MAJOR PROJECT ASSESSMENT
Water Related Services for the North West
Growth Centre
Sydney Water Corporation

Director-General's
Environmental Assessment Report
Section 75I of the
Environmental Planning and Assessment Act 1979

November 2008

Figure 6: Odour Impact Assessment for the Riverstone Sewage Treatment Plant (Ultimate Capacity)

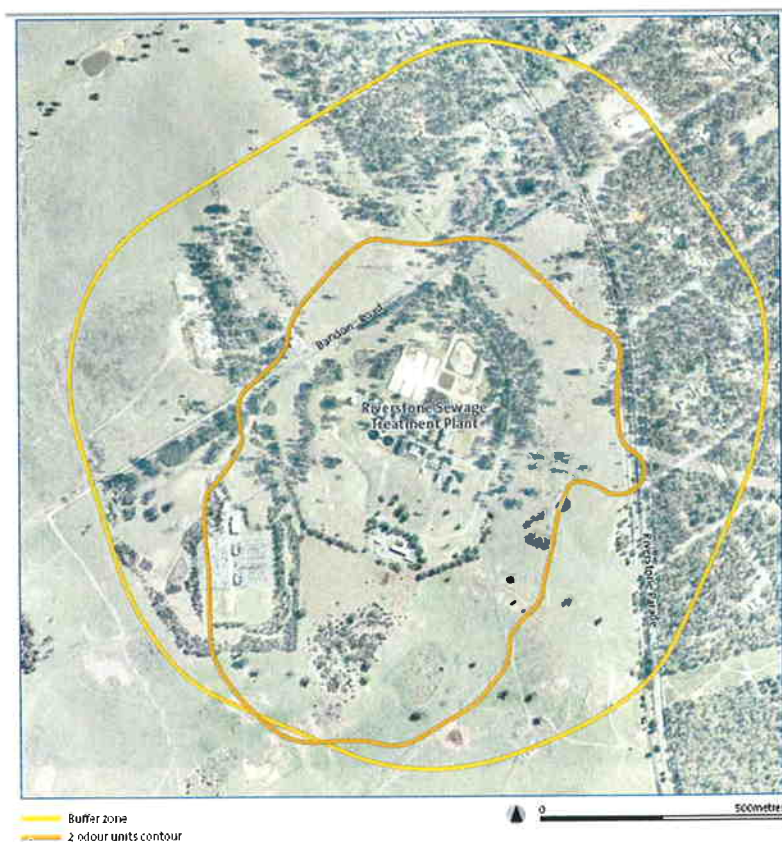
In its submission on the project, the DECC questioned the validity of the Proponent's odour assessment, stating that the modelling did not reflect worst case scenarios at the plant, and did not provide details of all key operational assumptions upon which the modelling was based. The results provided by the Proponent were likely to be an underestimation of the actual odour impacts from the plant operating at 35ML/day.

The Proponent's original odour impact assessment for the Riverstone Sewage Treatment Plant was problematic. Firstly, the assessment was based on the plant operating at a capacity of 35ML/day, even though the capacity for which the Proponent is applying under the current project application is only 14.2ML/day. Secondly, although the assessment clearly indicates that odour levels beyond the boundary of the site would significantly exceed levels considered offensive in residential areas (2 odour units), the Environmental Assessment remained silent on any management or mitigation issues to address this impact. Finally, the DECC found significant methodological flaws with the assessment, and questioned the validity of the results.

However, the Proponent's modelling also suggests that odour emissions above 2 odour units are unlikely to affect future residential areas, even at full capacity. While DECC questioned the validity of the modelling, discussions between the Proponent and DECC suggested that any additional impacts beyond the modelled area would most likely occur in the south, and not in the areas of future residential development to the east. Again, the Department is confident that the Proponent will be able to resolve odour impacts associated with the ultimate capacity plant in consultation with DECC and the Growth Centres Commission.

Figure 7: Revised Odour Impact Assessment for the Riverstone Sewage Treatment Plant (14.2ML/day Capacity)

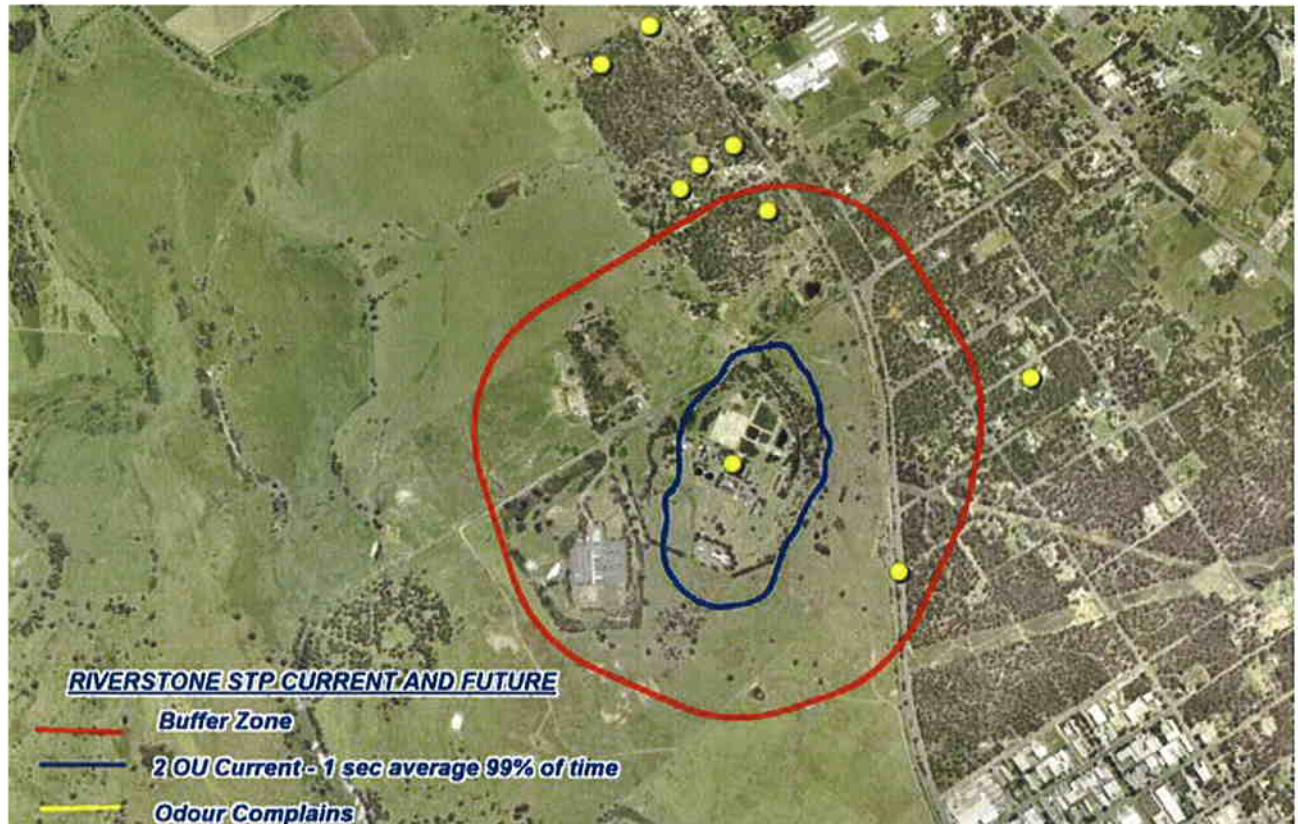
To address these concerns, the Department convened a meeting between the Proponent, the DECC and the Growth Centres Commission. The Proponent was required to provide revised modelling results which addressed the methodological requirements of the DECC and that reflected the capacity of 14.2ML/day sought under the current project application. The Proponent provided these results in the Preferred Project Report and they are shown in Figure 7.

These results indicate that, under worst-case conditions, some areas beyond the site would be affected by odour levels above 2 odour units, but that the majority of the odour impacts would be contained within the site. The DECC indicated that the methodology behind these revised results is acceptable.

Furthermore, the above results reflect worst-case scenarios, and the Proponent has indicated that emissions above 2 odour units outside of the site are highly unlikely when the capacity of the plant is only 14.2ML/day. Therefore, the recommended conditions of approval require the Proponent to comply with section 129 of the *Protection of the Environment Operations Act 1997*, which prohibits the emission of offensive odours beyond the boundary of the site.
